SEALE 351.25 ACRE TRACT MASTER DEVELOPMENT PLAN

Re: Seale 351.25 Acre Tract Subdivision (Amendment) MDP # 791-B

The City Staff Development Review Committee has reviewed Seale 351.25 Acre Tract Subdivision Master Development Plan (M.D.P.) # 791-B Amendment. Please find enclosed a signed copy for your files. Your plan was accepted however please note the following:

70' TYPICAL STREET SECTION
SCALE: HORZ. 1"= 10'
VERT. 1"= 5'

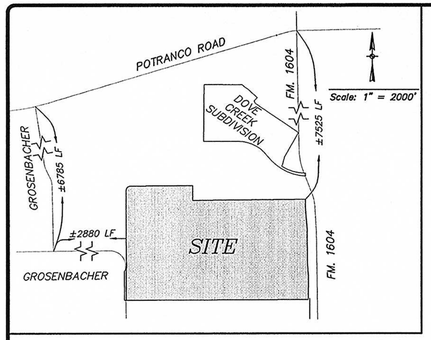
2. Construction of an internal east-west collector street system approximately 3800-feet in length. Collector street design parameters consist of 70-feet of ROW and 44-feet of pavement (Table 506-3). The proposed collector street shall have no houses fronting (UDC 35-515, ©,(4)).

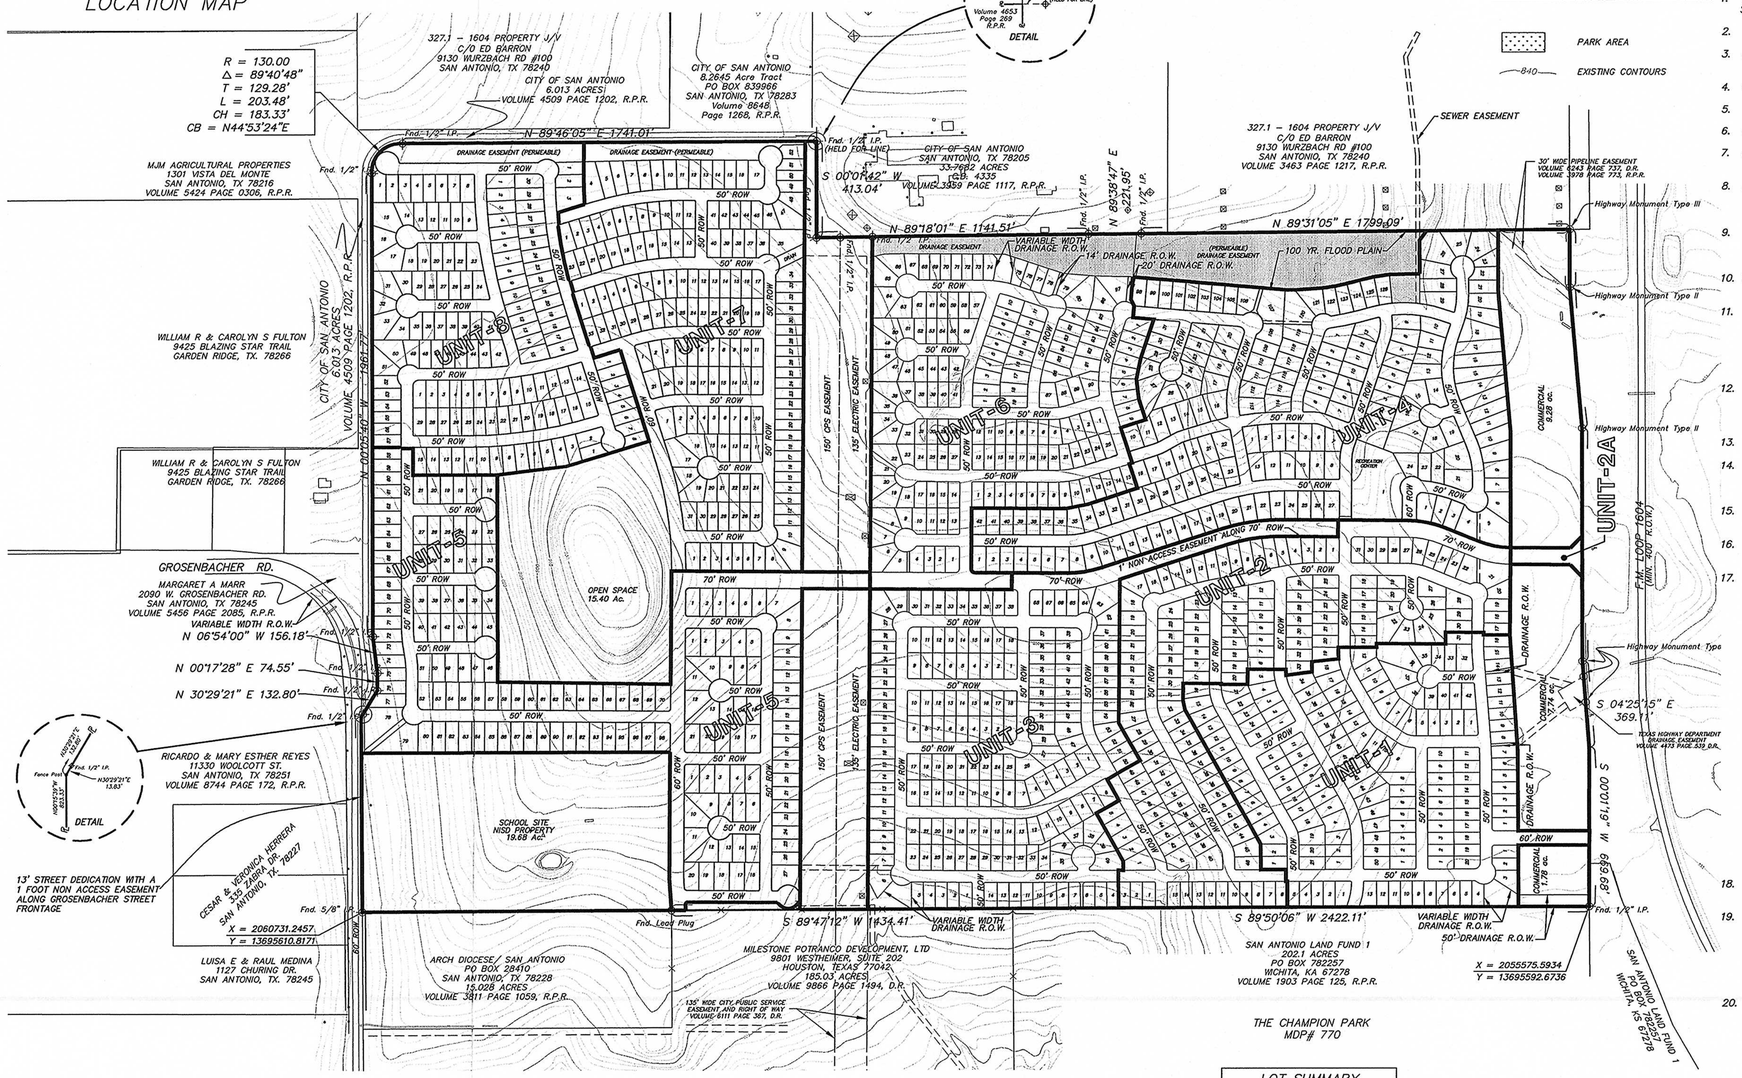
- In consideration of public safety and convenience, excessive grades by reason of topography should be avoided in street layouts and arrangements.

- The acceptance of this Master Development Plan # 791B is confined to the boundary limits of the site. Any projection(s) of future roadways outside the boundaries does not infer any set alignment of future roadways. All major arterials and streets shall follow all regulations.

- It should be understood that note 14, 15 on the plan does not waive requirements of UDC section 35-412 that states MDP shall be conformed to in processing any Application for rezoning, Traffic Impact Analysis (TIAs), subdivision plats (minor and major), PUD Plans, and /or Utility Master Plans.

- It should be understood the current alignment of the proposed roadways on the Seale tract does not match the approved MDP #770, Champions Park. All roadways shall be aligned at the time of platting per UDC section 35-506 (e)(2).

- It will be expected that you will plat all of the property depicted in your Master Development Plan (M.D.P.), to include: flood plains, drainage areas and open space.

- Historic Preservation Design and Review Division, Department of Planning and the City Parks and Recreation Department and the applicant of this MDP agree that Padron Hill shall be preserved and protected as a natural area. There is a dedication requirement of 14.0 acres

for the submitted plan. The donation of the hill of approximately 13.65 acres as a natural area precludes the payment of an in lieu of fee and required development, in accordance with Section 35-503 of the UDC. This, in combination with other parkland submitted in the plan, will meet the City's park dedication requirement.
